22 March 2024

Enquiries: Andrew Farran  
Project No: 301400273

**RE: Thornton Central Village  
Response to Submissions**

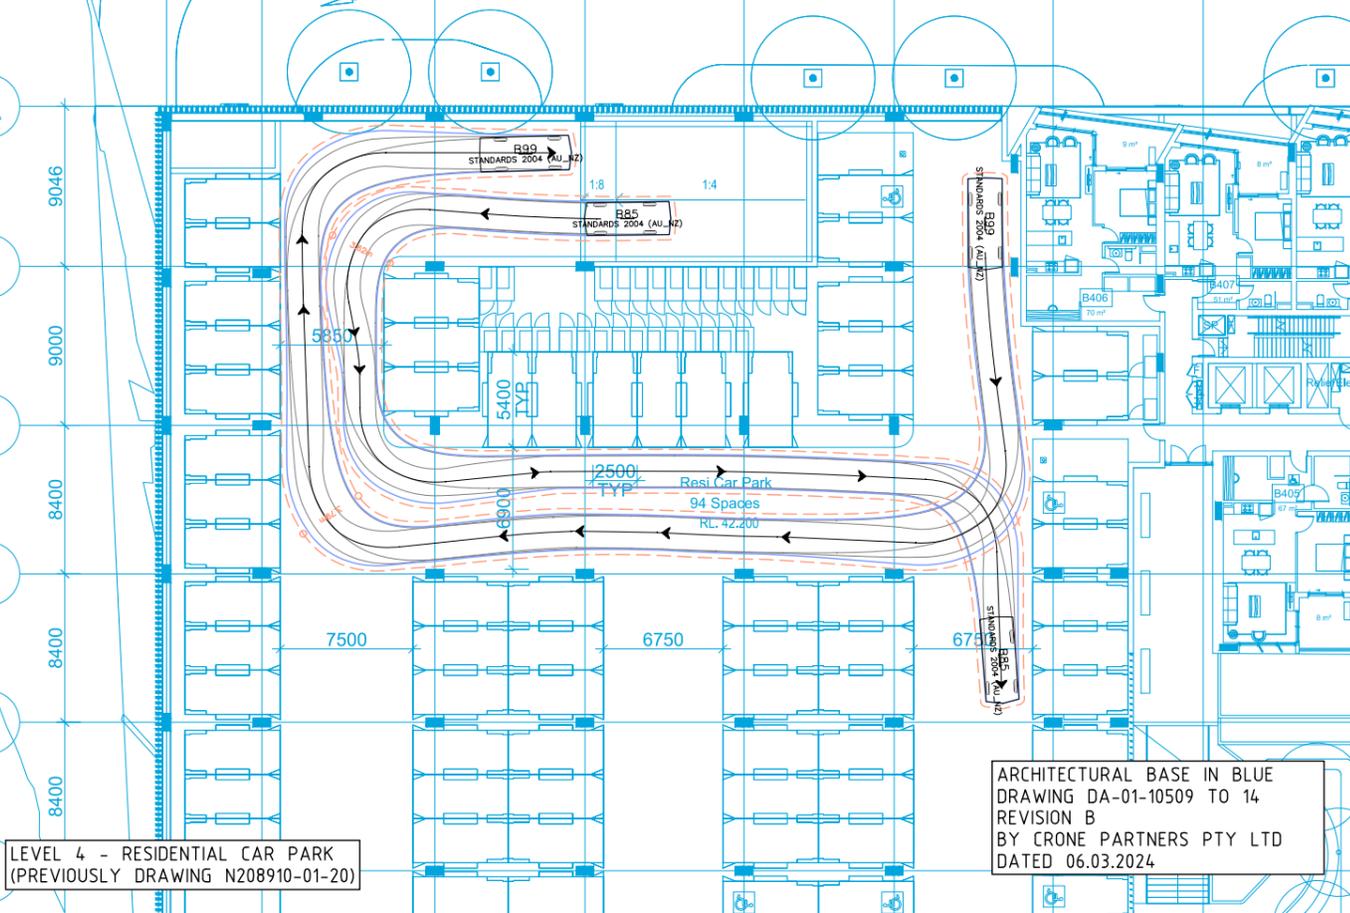
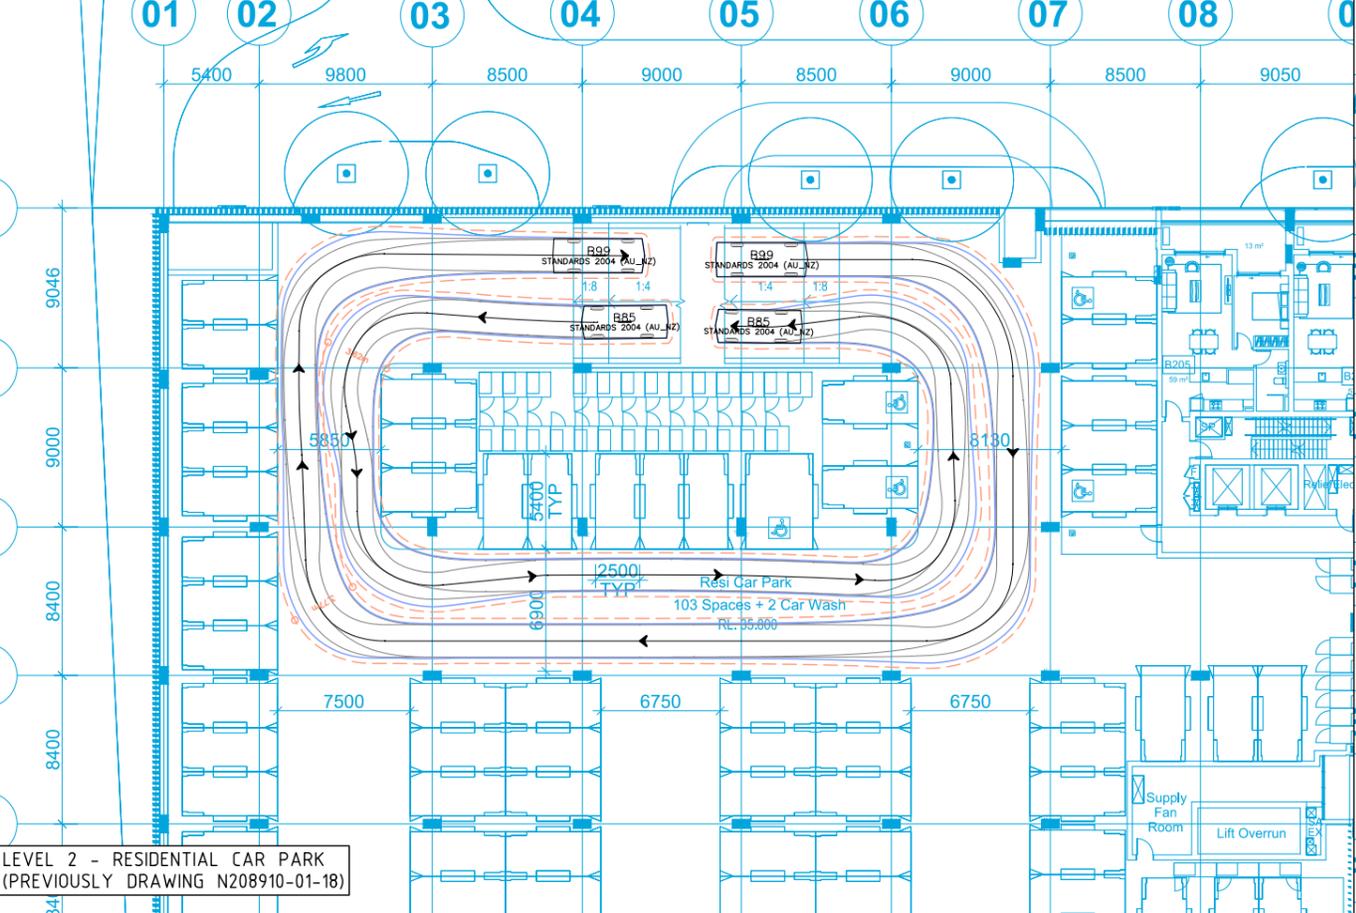
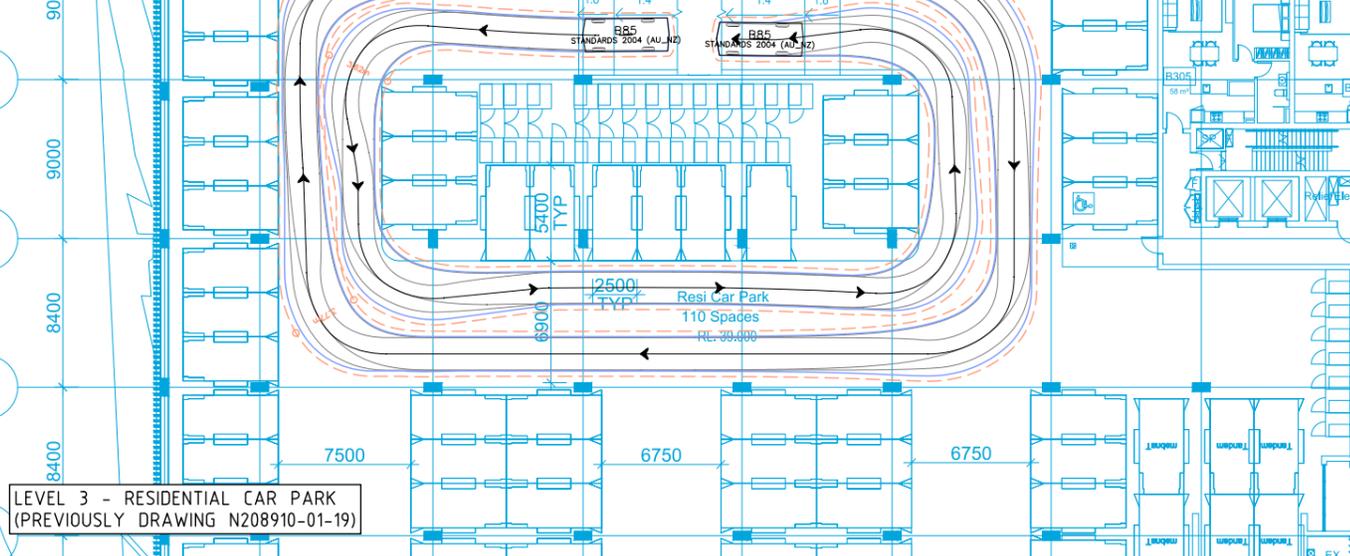
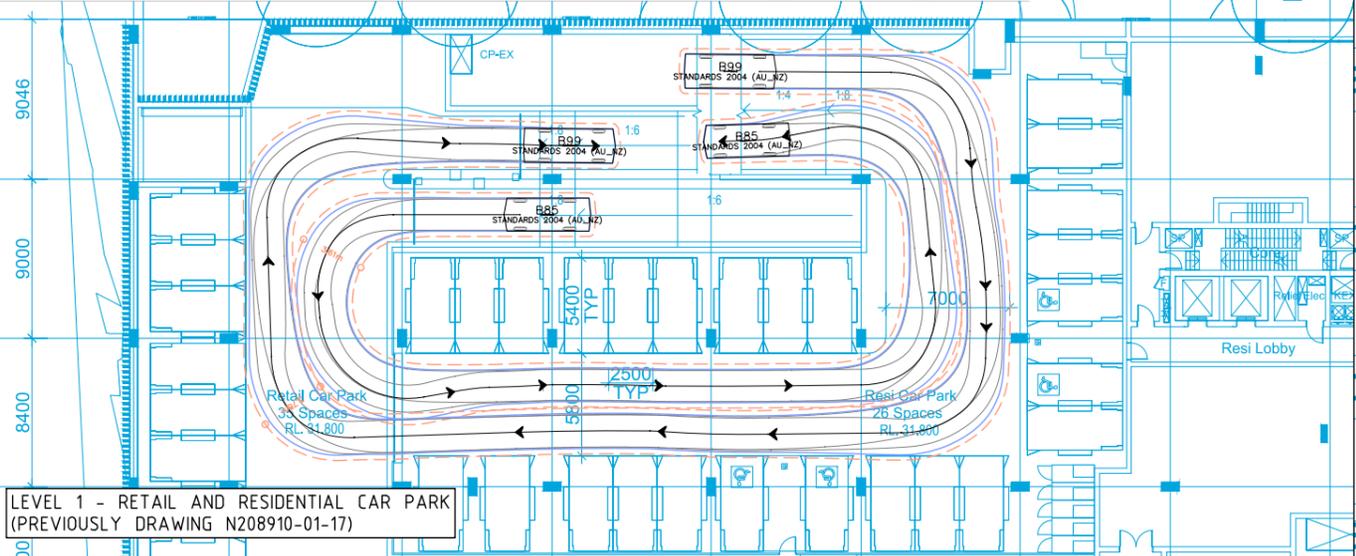
***A II: The submitted swept path diagrams are not satisfactory. Sheets 17 – Sheet 20 of the swept paths indicate that vehicles do not have clearance from one another when passing in opposite directions around the corners within the car park, including the ramps. The development shall provide for two-way movement of vehicles, demonstrating satisfactory turning through aisles, around corners and accessing ramps without conflicting with vehicles travelling in the opposite direction. In addition, Sheet 6 indicates an aisle to be extension is required and conflicting column with turning movements. This shall be amended on the plans.***

The car park layout and circulation has been designed in accordance with AS2890.1:2004. The key circulation paths were previously tested with simultaneous B99 vehicle movements. Whilst considered an appropriate testing scenario for key circulation pathways for retail land uses (although not required by the Standards), simultaneous B99 vehicle movements are not considered necessary for a residential car park.

In this respect, updated swept paths have been completed (of sheets 17 to 20 from DA1 and sheets 21 to 25 of DA2) to demonstrate simultaneous circulation of the residential car parking areas using a B85 and B99 vehicle. The swept paths are provided at Attachment 1.

As identified on the plans (Sheet 6) the identified conflict is proposed to be resolved at the detailed design stage, with coordination with the structural engineering team.

DRAWING NO. 301400273-01-03 SHEET 03 OF 04 ISSUE P1

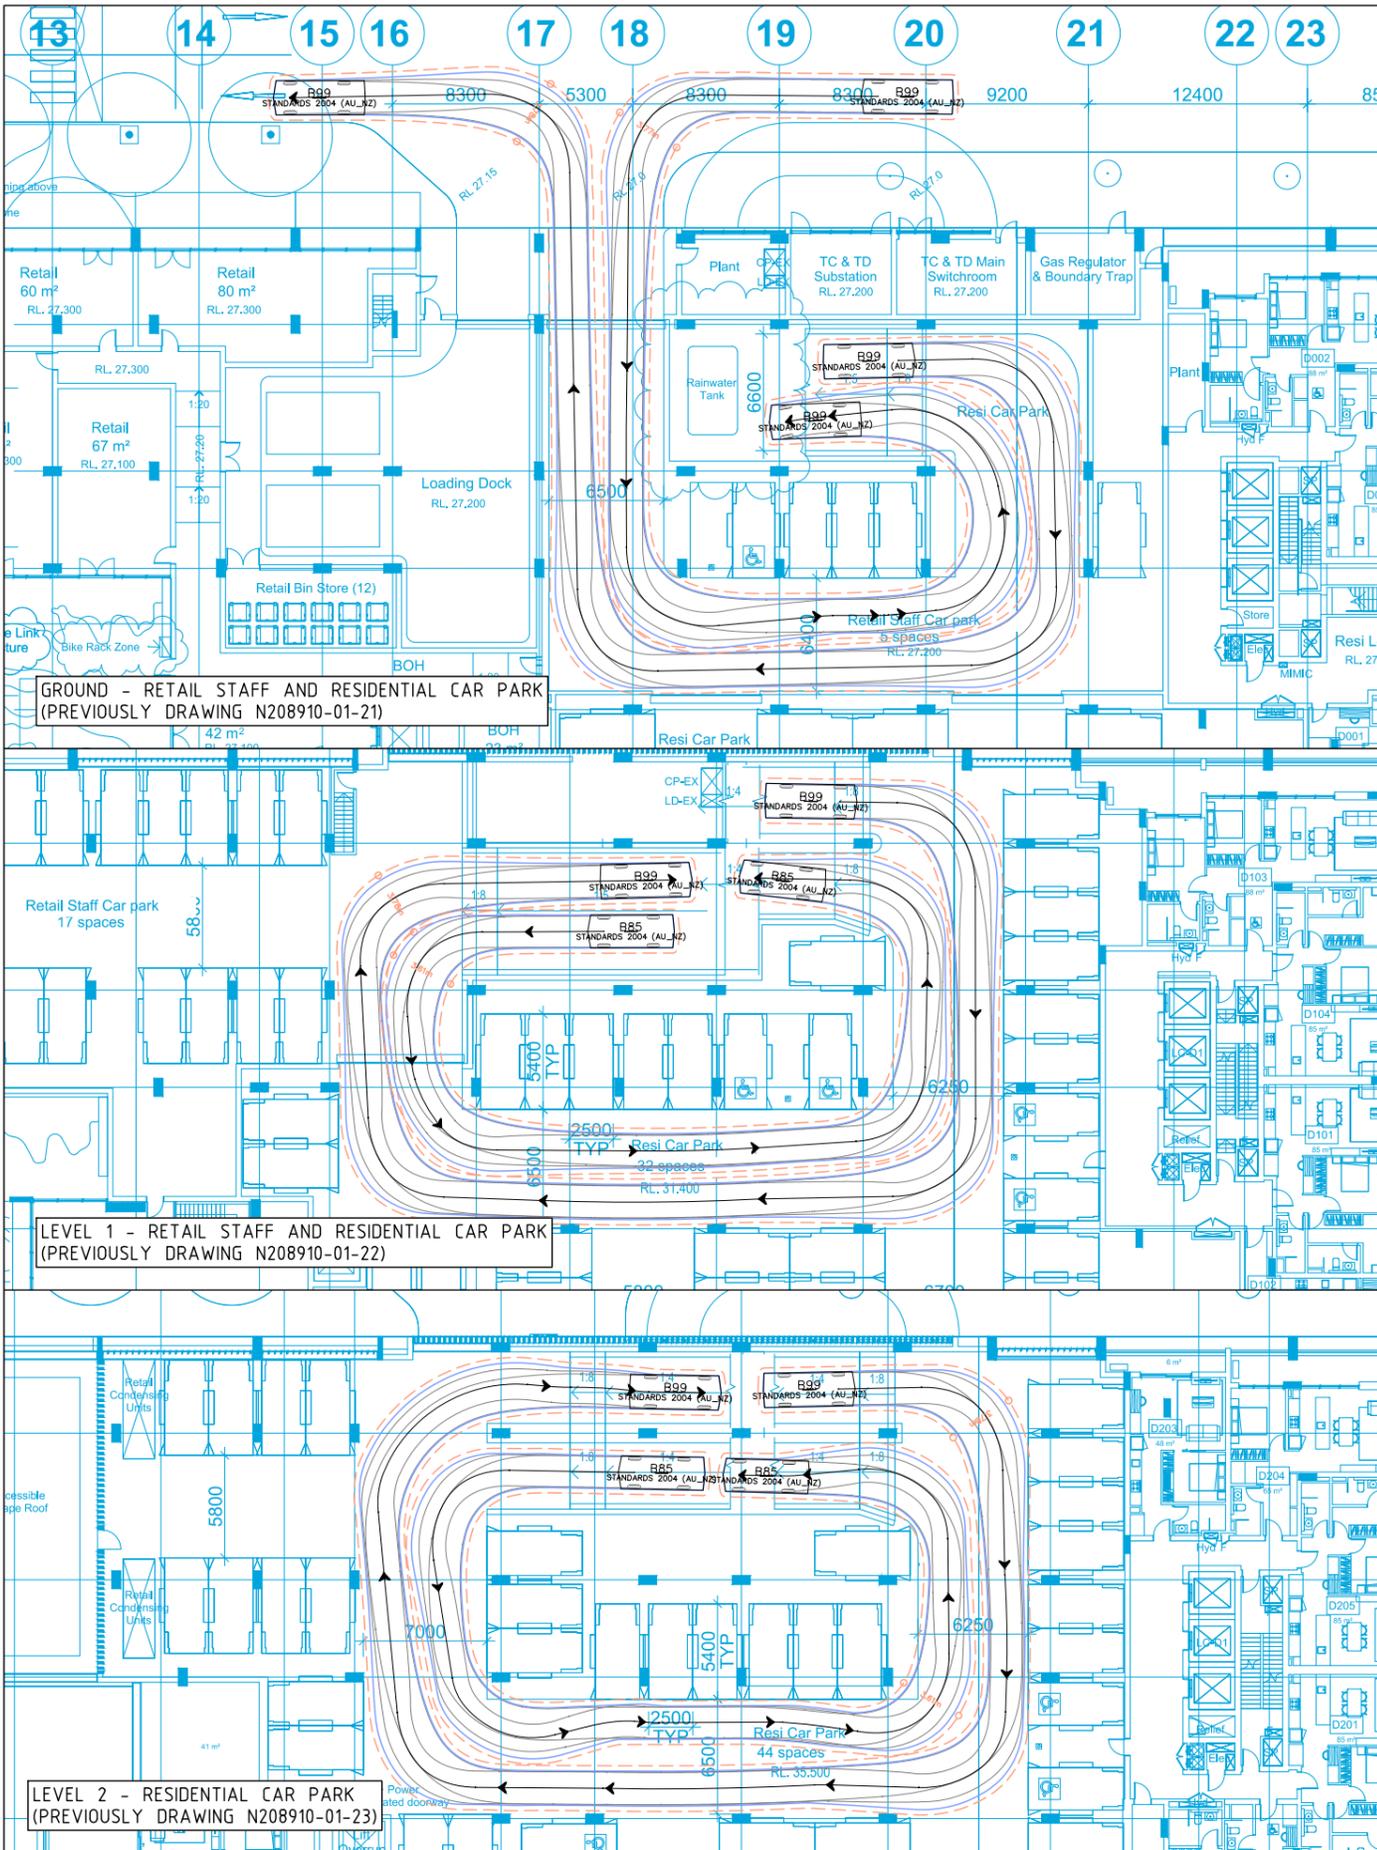
**A II: The submitted swept path diagrams are not satisfactory. Sheets 21– Sheet 25 of the swept paths indicate that vehicles do not have clearance from one another when passing in opposite directions around the corners within the car park, including the ramps. The development shall provide for two-way movement of vehicles, demonstrating satisfactory turning through aisles, around corners and accessing ramps without conflicting with vehicles travelling in the opposite direction. In addition, Sheets 3 and 4 indicate columns to be located. This shall be amended on the plans.**
